**ENGINEERING, OPERATIONS AND PLANNING COMMITTEE MEETING  
AGENDA**

**THURSDAY, JULY 25, 2024 - 6:00 PM**

**DATE:** July 25, 2024  
**TO:** Engineering, Operations and Planning Committee  
**FROM:** Rocky Welborn, Director of Engineering  
**SUBJECT:** CHANGE ORDER NO. 5 WITH PCL CONSTRUCTION, INC. FOR THE OLIVER P. ROEMER WATER FILTRATION FACILITY UPGRADE AND EXPANSION PROJECT

## Ret. Wall Option 2

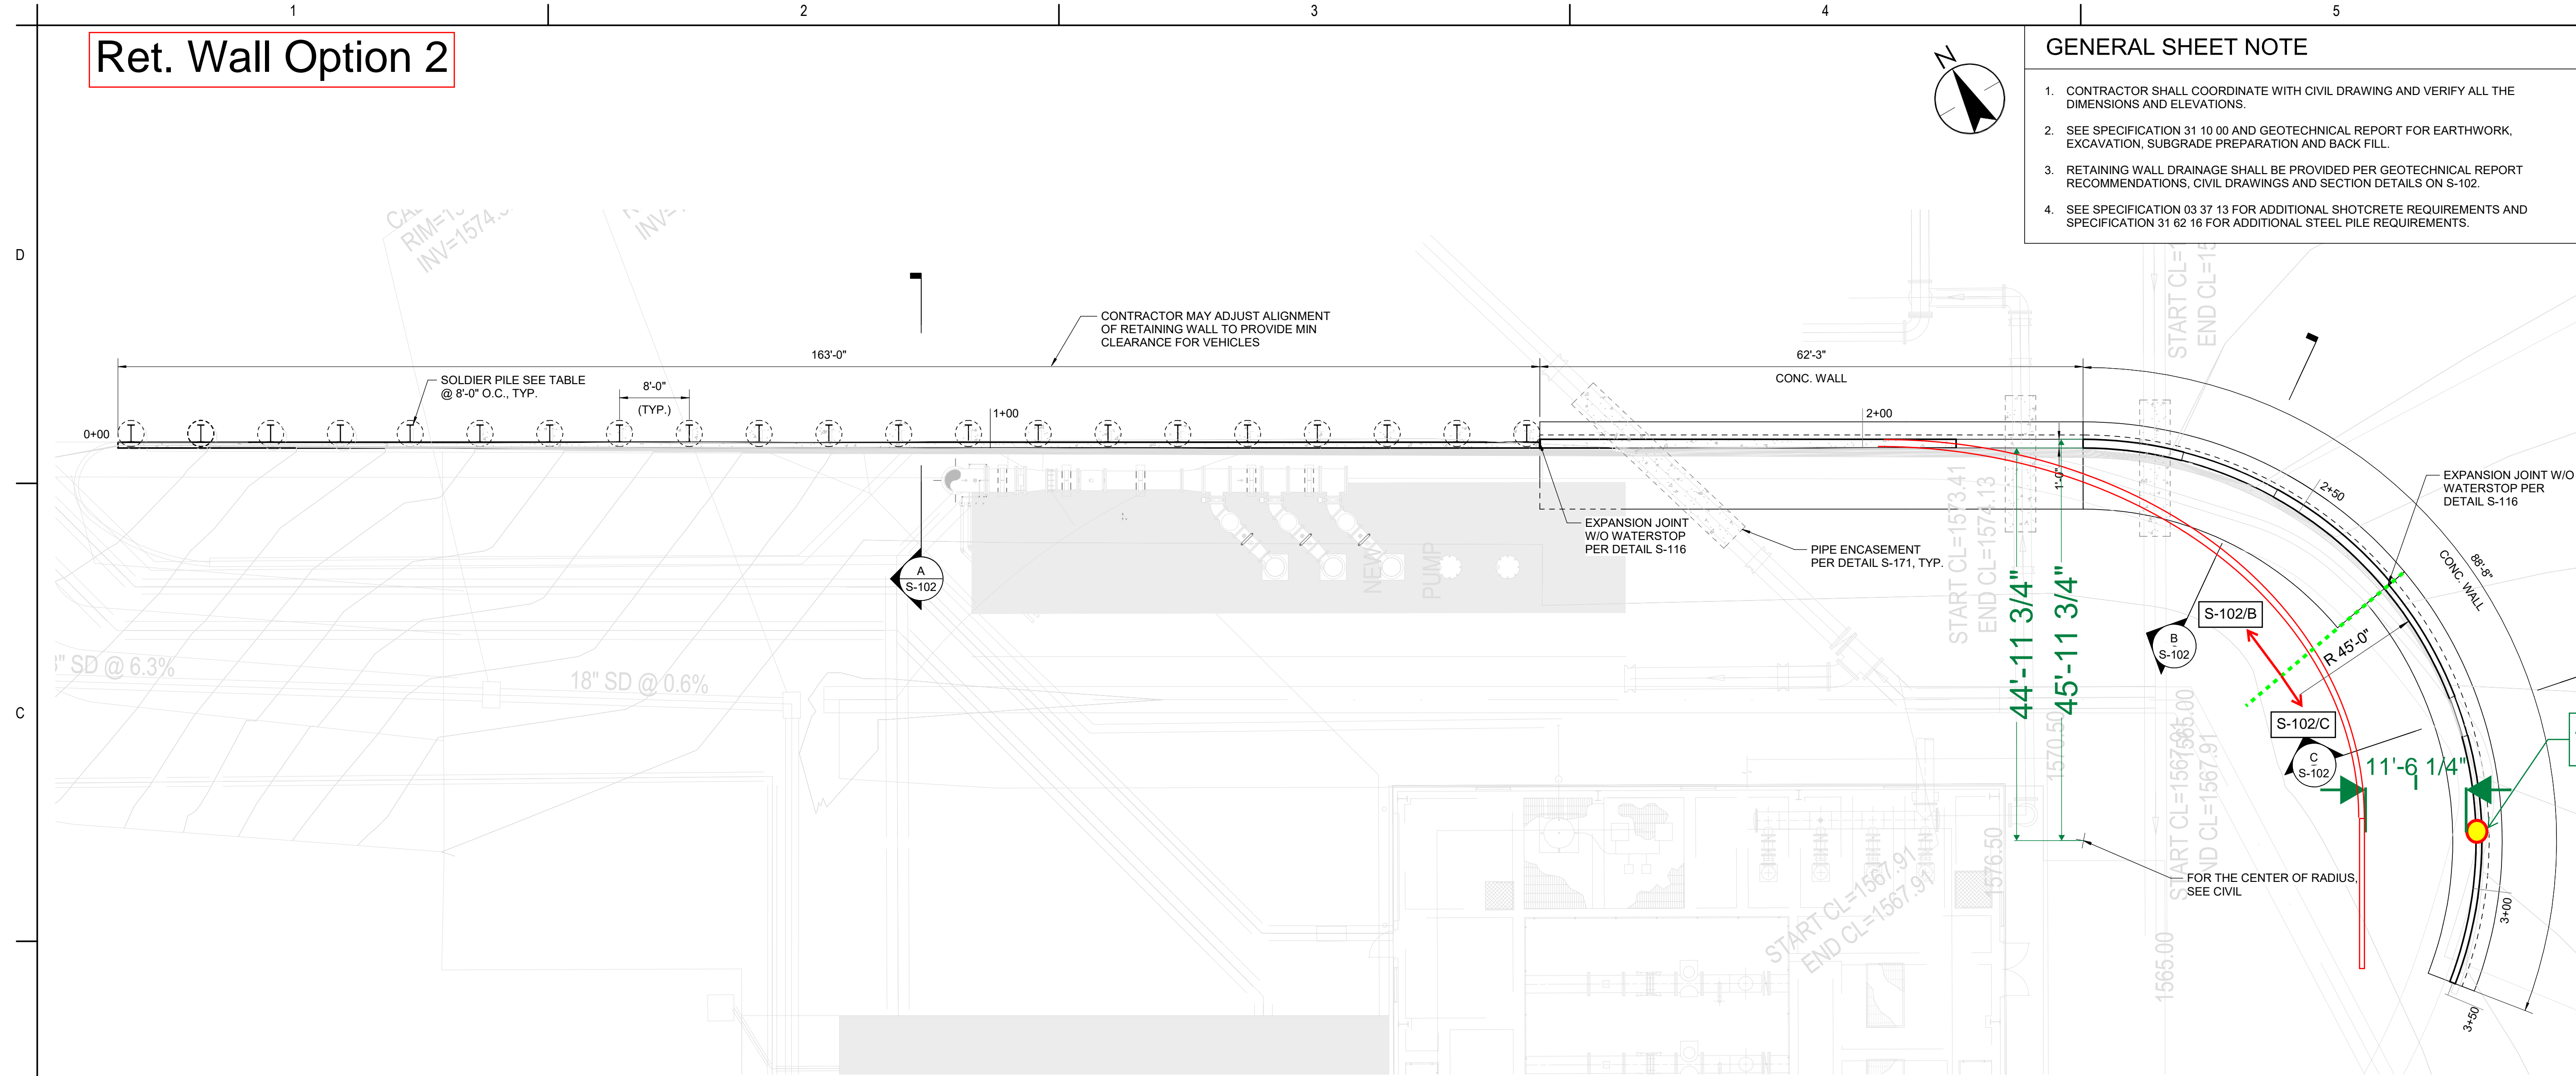
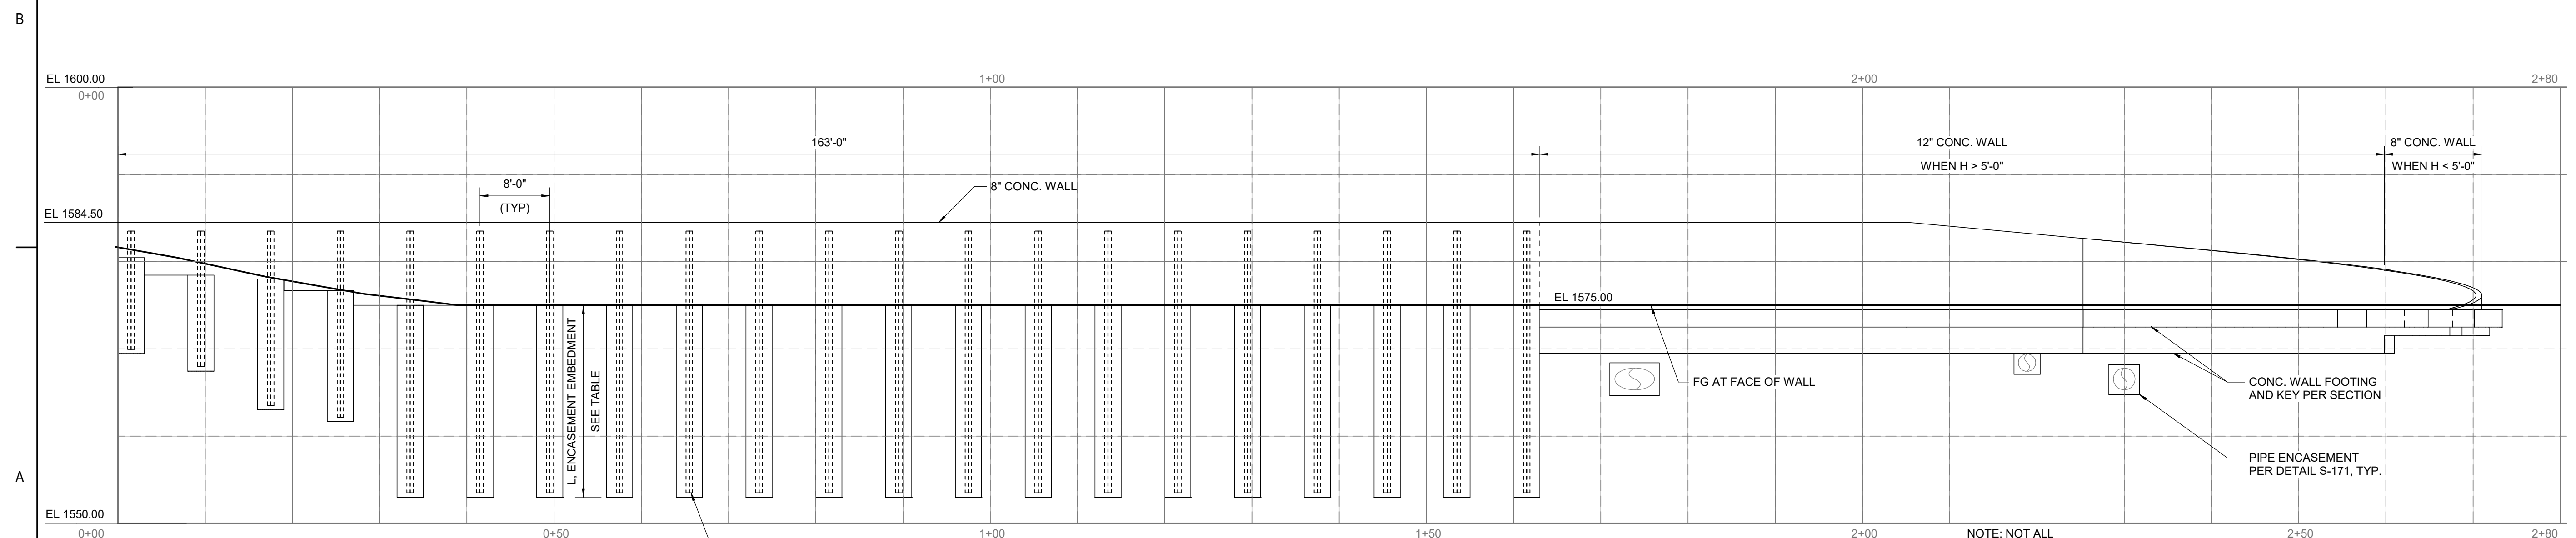
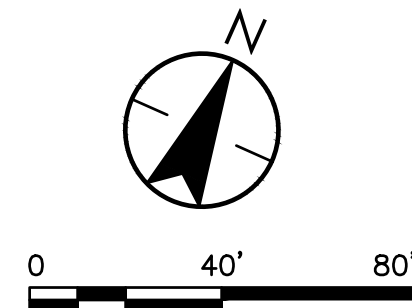
Please accept the attached package as a Change Request for the Retaining Wall Redesign. PCL notified the District on January, 23 2024 of the differing site condition that an unforeseen fiber optic vault and interconnecting duct banks were conflicting with the proposed retaining wall. As mentioned in the email correspondence, neither the vault or duct banks were provided in any of the record drawings or 30-percent contract documents. Therefore, we see these utilities as a differing site condition. Below is a summary of the additional work created due to this unforeseen condition.

- Additional potholing was needed to verify that a reroute would entirely avoid these fiber optic duct banks.
- Structural and Civil Redesign to the retaining wall.
- Replacing the existing fiber optic vault with a traffic rated vault.
- Additional backfill needed to bring the widened road to elevation.

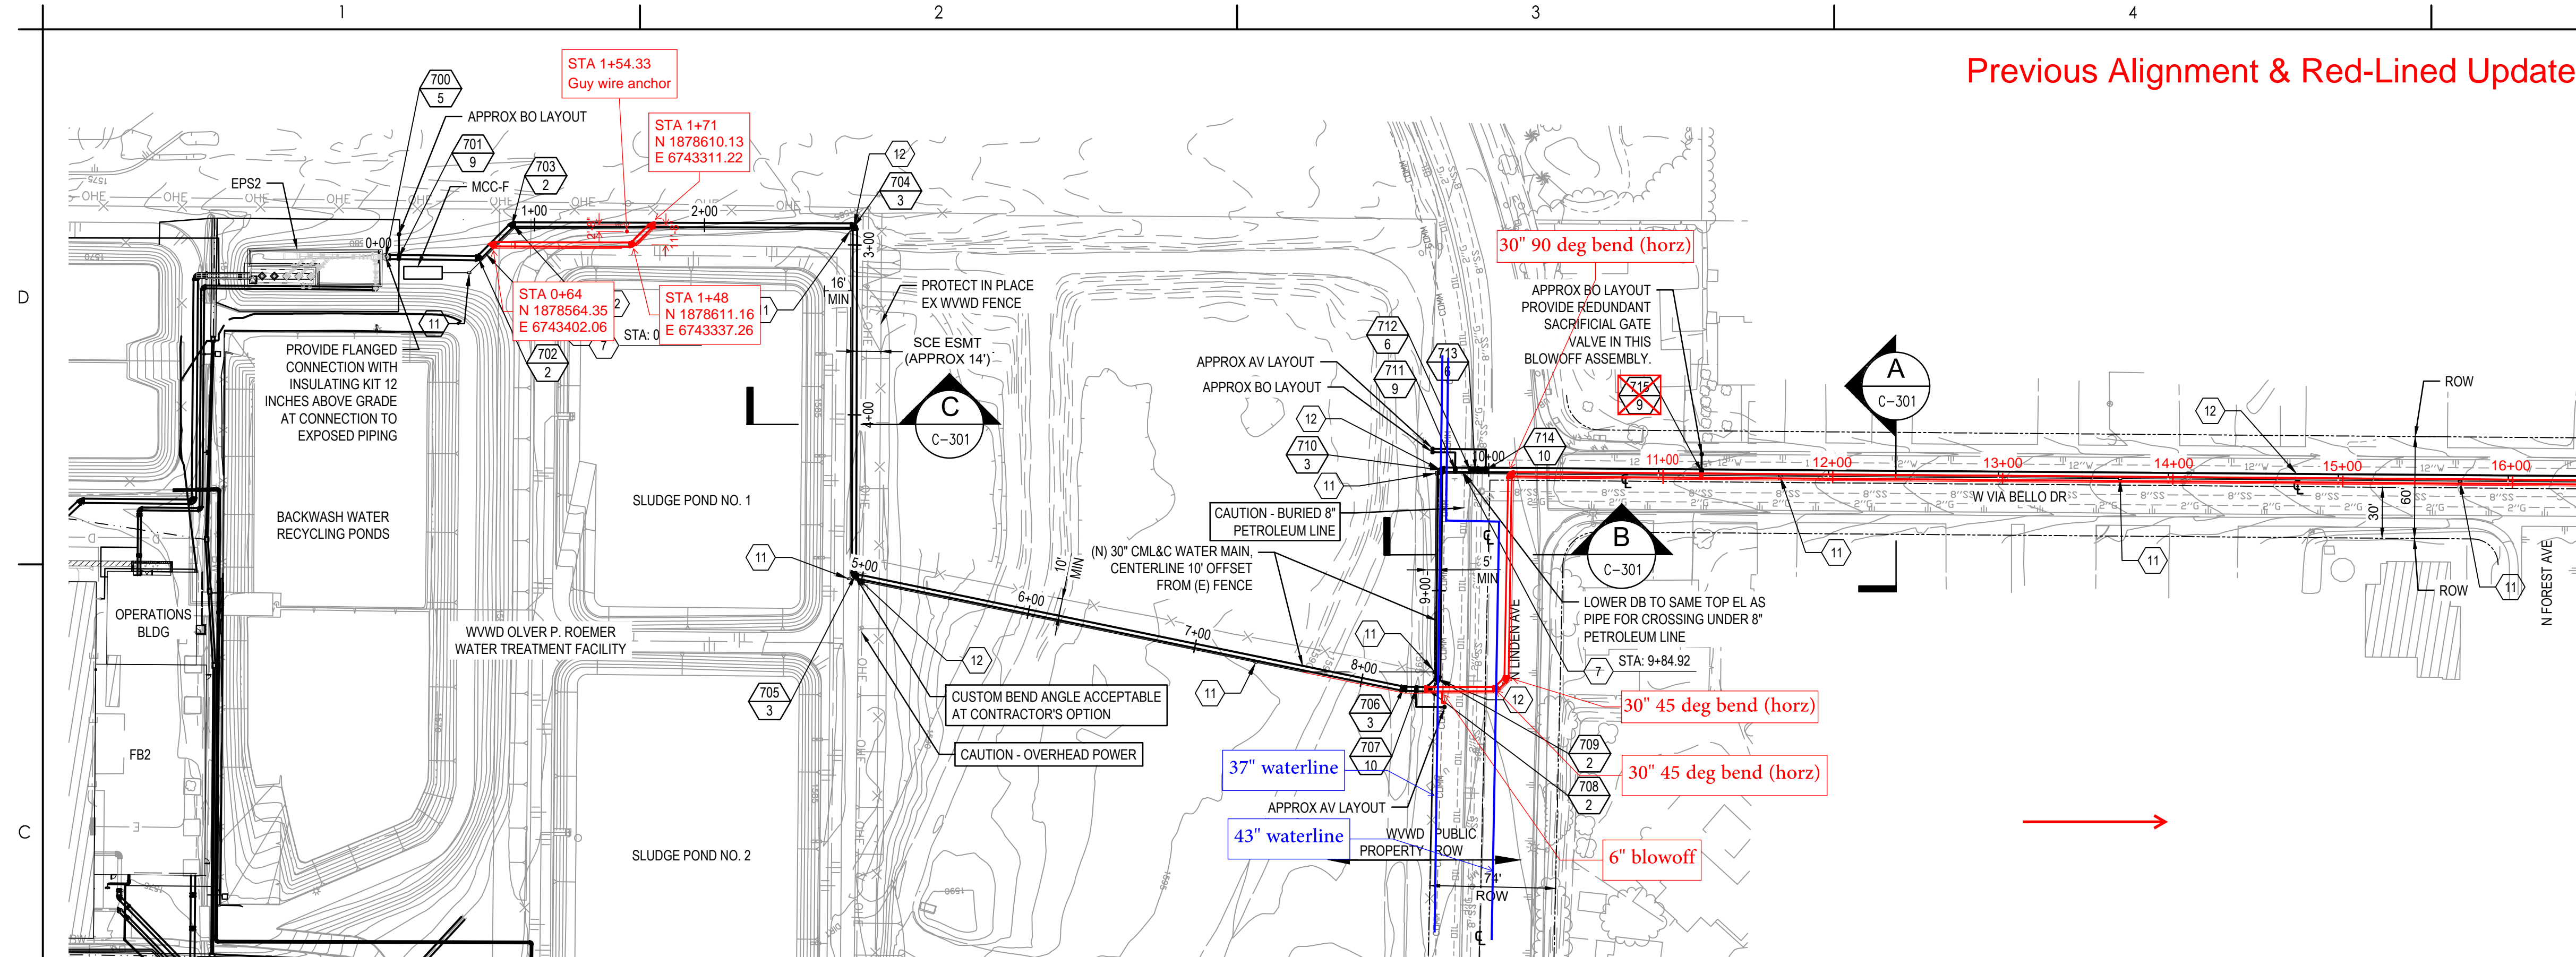
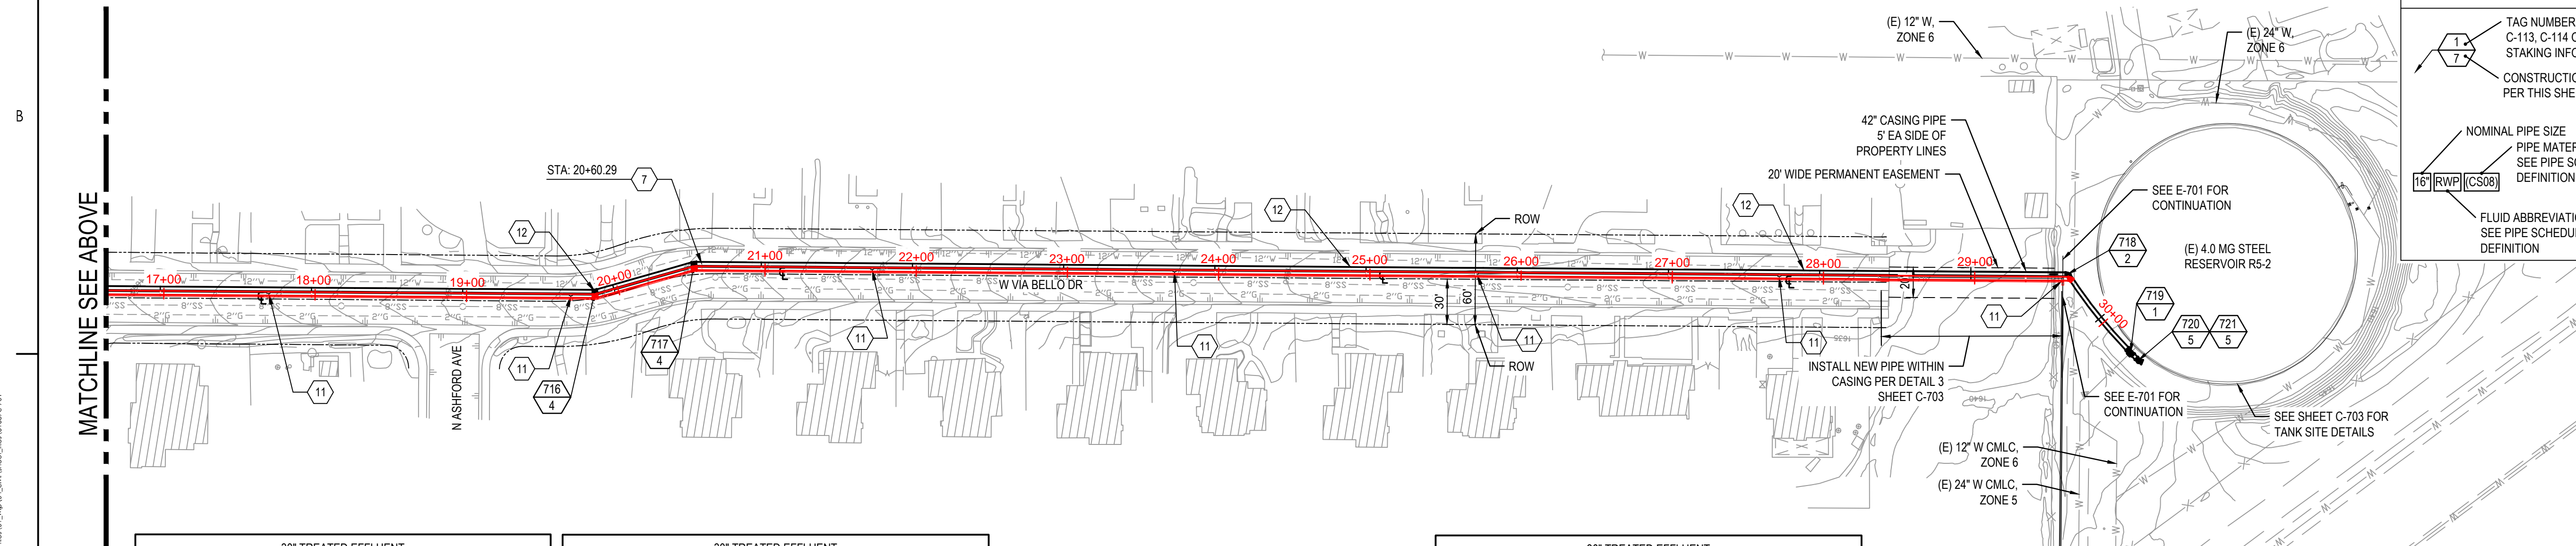
Please accept the attached package as a Change Request due to the cost impacts caused by unforeseen water lines found in Linden Ave and West Via Bello Dr. Three unforeseen underground water lines classified as 37-inch CML-C, 43-inch CML-C and a 12-inch Asbestos Cement Pipe (ACP) were discovered during potholing activities performed by subcontractor Ferreira Construction Co. in preparation for the installation of 30" treated water main connecting the Effluent Pump Station to Reservoir R5-2. The record drawings provided at the time of proposal did not show any of these unforeseen lines. As part of the investigations performed out in the field, it was determined the 37-inch & 43-inch water lines belong to Fontana Water Company and the 12-inch ACP pipe belongs to West Valley Water District.

- Upon potholing, two waterlines (a 37-inch and 43-inch) belonging to Fontana Water Company were identified within Linden Ave. The location of the aforementioned pipelines conflicts with the proposed location of the new 30-inch water main that will connect the Oliver P Roemer Water Filtration Facility to the Reservoir R5-2. Therefore, the alignment of the new water line had to be revised to avoid the existing lines. Whereas the previous design's routing followed the shoulder along Linden Ave before turning 90-degrees up W Via Bello Dr., these findings determined the only constructable window for the water main now within Linden Ave, which requires additional efforts in order to be installed. The additional efforts include but are not limited to, additional potholing activities (tracked on time and material basis for further investigations within the area, extra depth for installing the water line within Linden, extra saw-cut, and additional repaving costs.

- In addition, the location of the two new pull boxes for the fiber line that connects the Roemer plant to the Reservoir will also be impacted due to the updated alignment in Linden Ave. Previously, the 30-inch water main's alignment within the shoulder of Linden Ave. allowed for these pull boxes to be set within the shoulder of the roadway at each of the waterlines 90-degree bend's to not exceed the fiber optic's maximum allowable bends of 180-degrees at finished grade in the water main's trench. From the new alignment, pull boxes would be required within Linden Ave. which the City of Rialto will not allow per the City's standards. To comply with

their standards, the two fiber optic pull boxes will need to be set within the south shoulder of Linden Ave. The additional efforts include but are not limited to, excavating new trench for the fiber conduit in the south shoulder of Linden Ave, an added crossing at Linden Ave. to reconnect with the fiber conduit being installed up W Via Bello Ave. requiring additional traffic controls, and backfilling the fiber conduit's trench and pull boxes.
